## Development Review Committee

**Re: Wollam Construction Office – Site Plan Request**

Application No.: SPR-616-2019  
Applicant: Matt Wollam, representing Wollam Construction  
Project Location: 12764 South Pony Express Rd  
Current Zoning: CR (Regional Commercial) Zone  
Acreage: 1.23 Acres (Approximately 53,578 ft<sup>2</sup>)  
Request: Request for approval of a site plan in the CR (Regional Commercial) zone regarding an office development.

# EXHIBIT E SITE PLAN

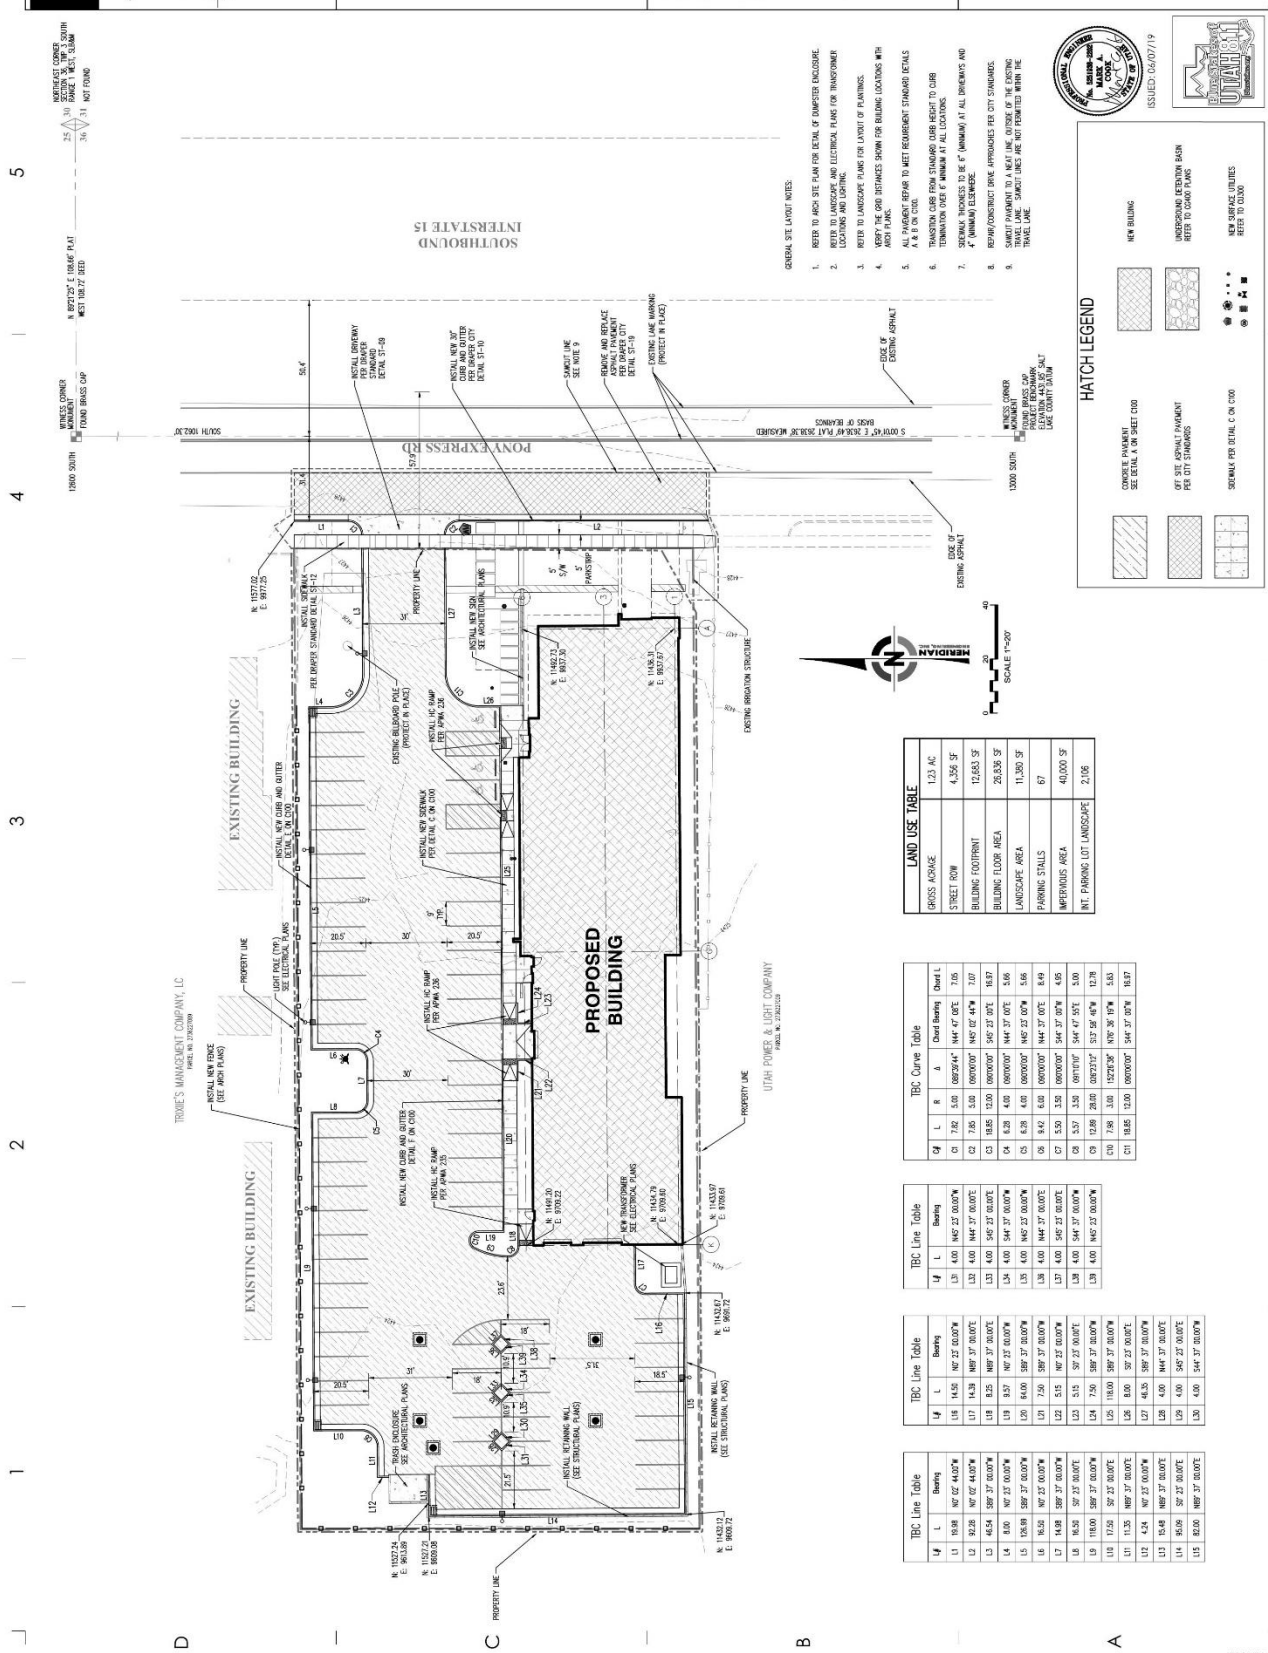
2. Fire Hydrants are required There are to be 2 hydrants are required. The hydrant shown on the plans is sufficient please show the distance and location of the hydrant on Pony Express Rd. They are to be protected with bollards if susceptible to vehicle damage.

# EXHIBIT F LANDSCAPE PLAN

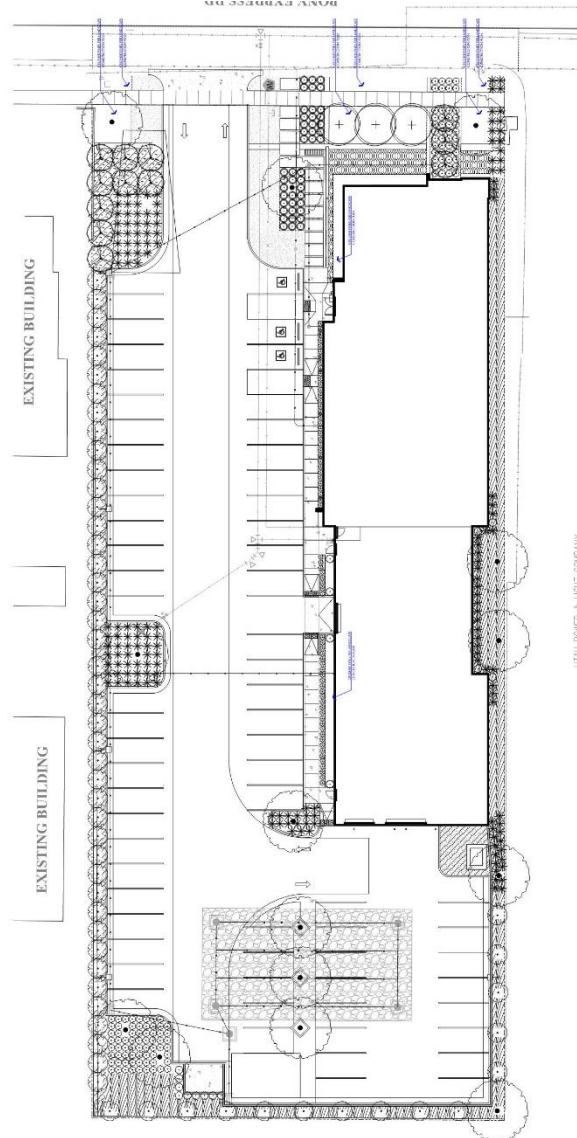
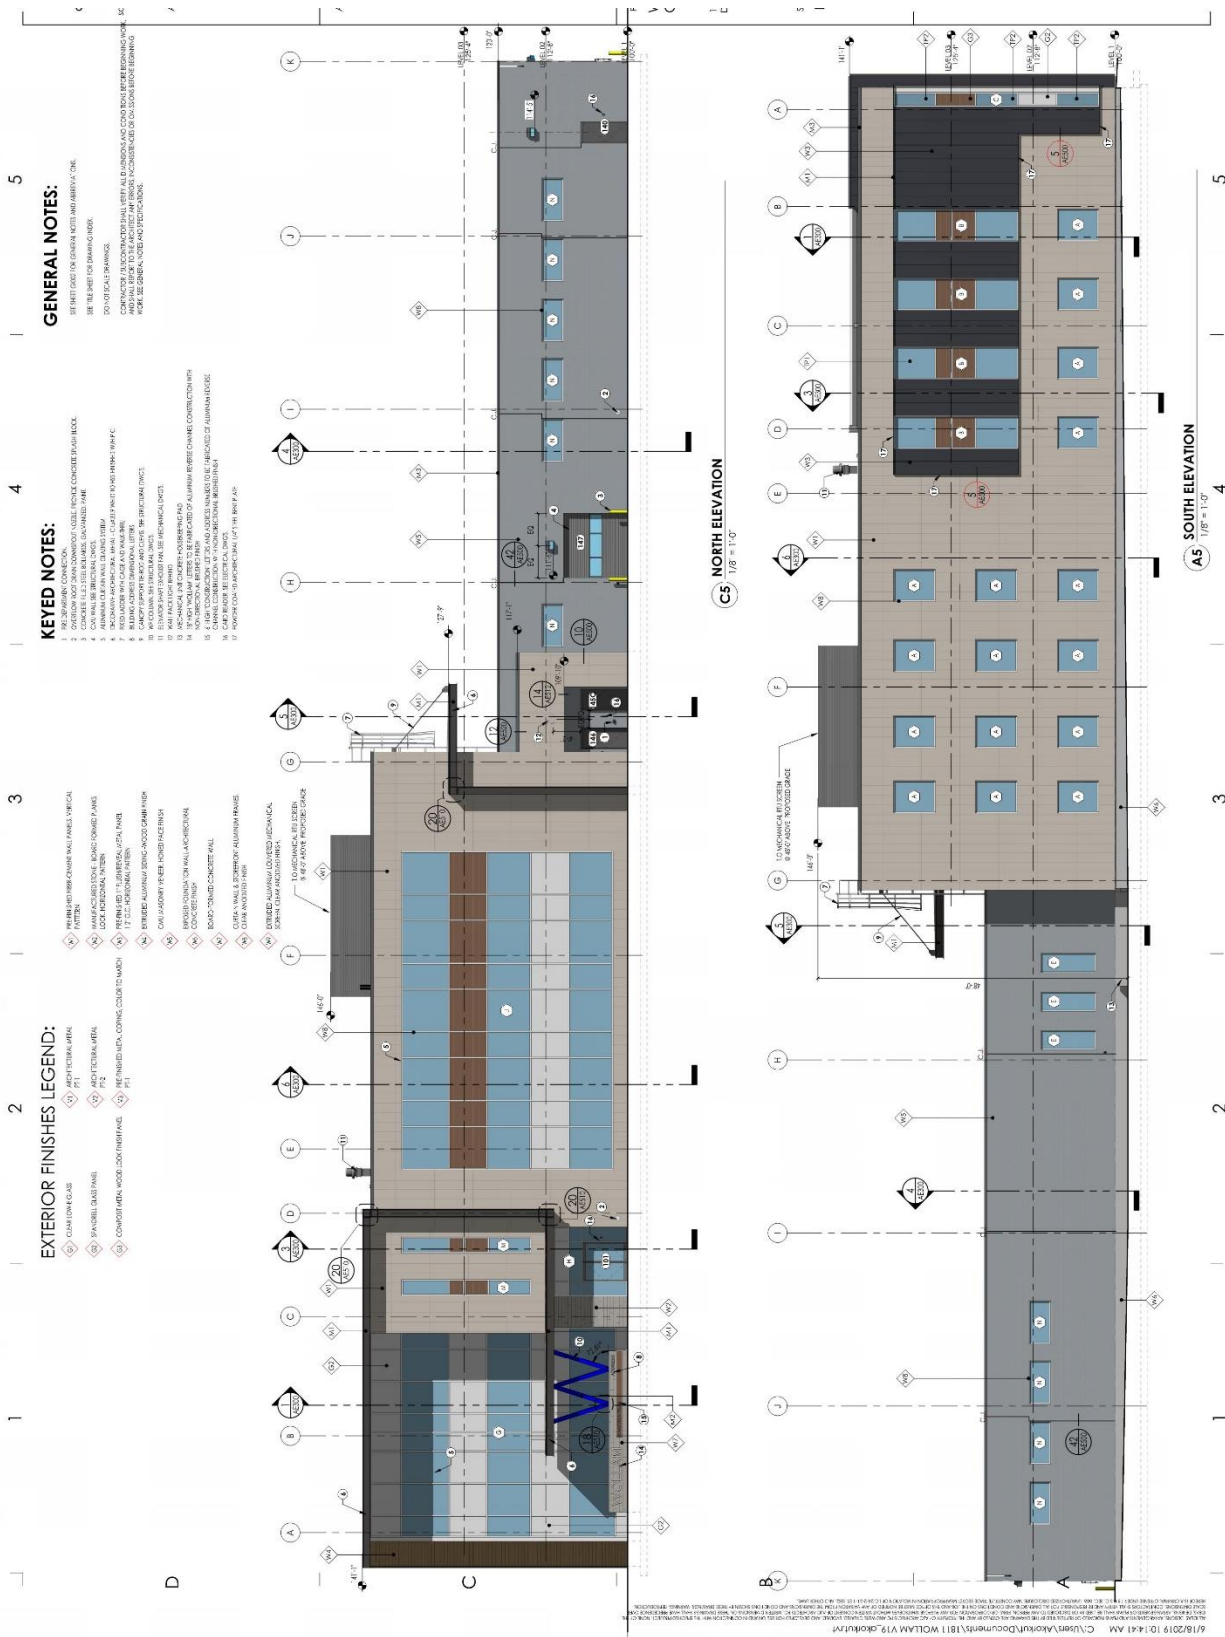
Landscaping Modification. The applicant is requesting two separate landscaping deviations for the property. The first is a reduction in perimeter landscaping. Draper City Municipal Code (DCMC) Section 9-23-090 requires at least 10-feet of landscaping around all property lines. The applicant is requesting perimeter landscaping of 5-feet along the north, south, and west property lines. DCMC Section 9-23-030 states that development constraints can vary greatly among sites and therefore the Planning Commission may approve landscaping plans that deviate from the landscaping requirements of the DCMC based on the following findings:

The second deviation requested by the applicant is to allow tree diamonds in place of a center island, and is specifically requesting three tree diamonds behind the building in order to allow vehicle-maneuvering area for the larger construction vehicles that will frequent the property. DCMC Section 9-25-080(H) requires center landscape islands in parking lots where rows of parking front each other. The Planning

1. The proposed landscaping deviations meet the findings standards within the code for deviations. If the applicant were to comply with all landscaping standards, a reduction in the amount of parking would be required.
2. The building roofline does not comply with architectural standards; however, the proposed design provides variations in both vertical and horizontal planes and provides a variation in building materials and windows. This helps break up the building and provide interest.

LANDSCAPE DEVIATION MITIGATION:  
LANDSCAPE DESIGN BEYOND MINIMUM REQUIREMENTS.  
UP SIZED PLANT MATERIAL  
PROVIDING AN ENHANCED, PEDESTRIAN FRIENDLY, INFORMAL ENTRY THAT INCLUDES TURF, LANDSCAPING WALLS, WALLS, AND DECORATIVE ROCK MULCH.  
ADDITIONAL ARCHITECTURAL FEATURE WALL AND FRONT ENTRY ENHANCEMENT.  
LOW LANDSCAPE FEATURE WALLS FOR ADDITIONAL CURB APPEAL AND SOUND MITIGATION.  
PROVIDING ABOVE AND BEYOND PLANT QUANTITIES PER MINIMUM REQUIREMENTS.

EXHIBIT G  
ELEVATIONS

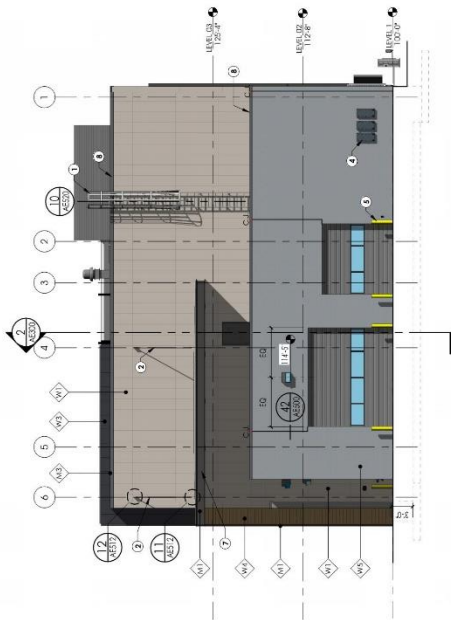
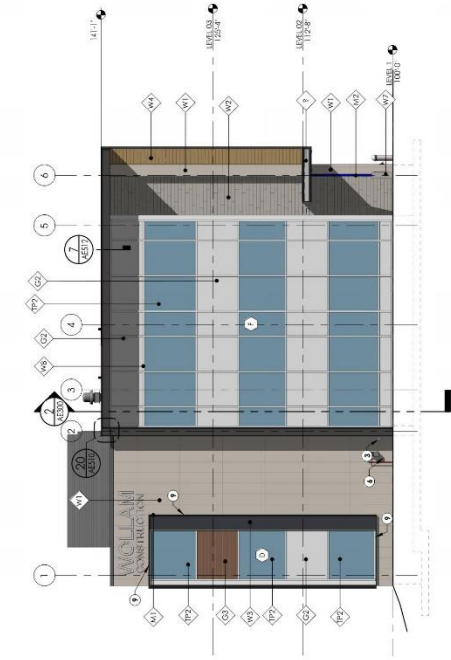
Architectural Design Standards Modification. The applicant is requesting a deviation to architectural standards. DCMC Section 9-22-040(D) requires rooflines with greater than 50-feet in length to include roofline and parapet wall variations. The proposed building has uninterrupted rooflines in excess of 50-feet. The roofline will have three main roof sections that will be uninterrupted moving from the front of the building to the back of the building. These sections will be 55-feet, 71-feet, and 107-feet. DCMC Chapter 22 authorizes the Planning Commission to approve deviations to strict compliance with the terms of the Code regarding development design standards for architecture. Specifically, DCMC Section 9-22-030 states that the Planning Commission may approve architectural plans that deviate from the requirements based on making at least three of the following findings:

The applicant has provided a breakdown of how the site complies with the deviation standards, as outlined in Exhibit H of this report. The site plan meets deviation criteria numbers 2, 9, 10, as outlined above. The site contains more than 10% plant material, the building is designed in a specific architectural style, and the use of primarily materials is at least 10% more than required.

The approval of the 48-foot tall building height is dependent on the deviation request to the Planning Commission.

**RESPONSE: The overall building height is less than the maximum allowed 45'. We are requesting additional height to screen the mechanical equipment. Revised deviation request will be submitted by the owner to the Planning Commission.**
